Formula SAE-A Rules Enquiries

Questions and Answers

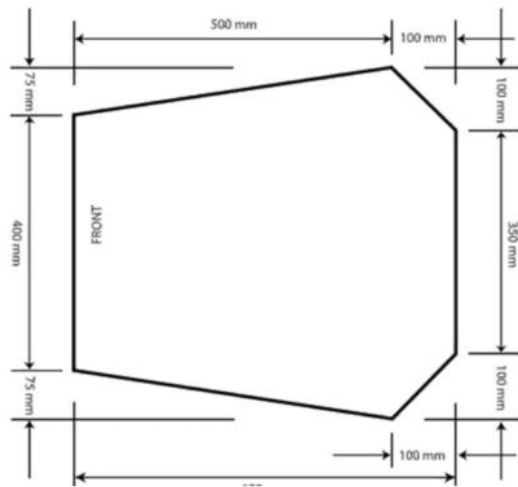
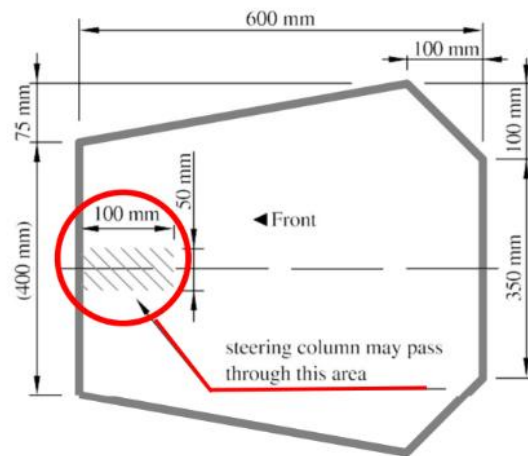
Question: FSAE rules T1.1.1 - cockpit opening template. We are designing our machine for it.

In Australasia competition. Is it same or not?

Aerodynamic Mounting Off Main Roll Hoop Bracing RE: 11-2019 - 07/04/2019

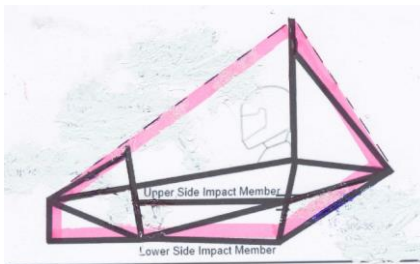
Question (part1): *I was planning to mount a bracket on the backside of the main roll hoop bracing that will then attach to the upper side of the rear wing as a mount (swan neck mount). However, I am confused as to what "additional bracing" must be added to the roll hoops to prevent bending loads in the braces in any rollover attitude?*

Question (part 2): *The rear wing was designed to have a bracket that is attached to the Main roll hoop bracing and top side of the rear wing. However, I am unsure what is classified as "additional bracing" and if there is any particular requirements that need to be met; such as specific areas where there needs to be additional mounting or specific bracing types.*

Answer: To avoid bending loads from anything mounted to the rear braces (such as a wing) from inputting a bending load to them, an additional tube would usually be required at the point where the wing mount attaches to the brace, creating a node which would then attach at the other end to a node on the Primary Structure, thereby creating triangulation and avoiding bending loads.

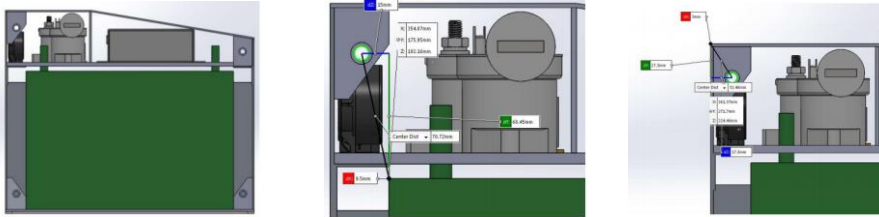
Our proposed cell arrangement is 90s8p. This is made of six segments of 15s8p connected in series. Within each segment, each series step is joined by a bus bar, such that the parallel strings are not separated.

In this arrangement, the parallel cells behave as one cell, and are subject to the overall pack over current protection.
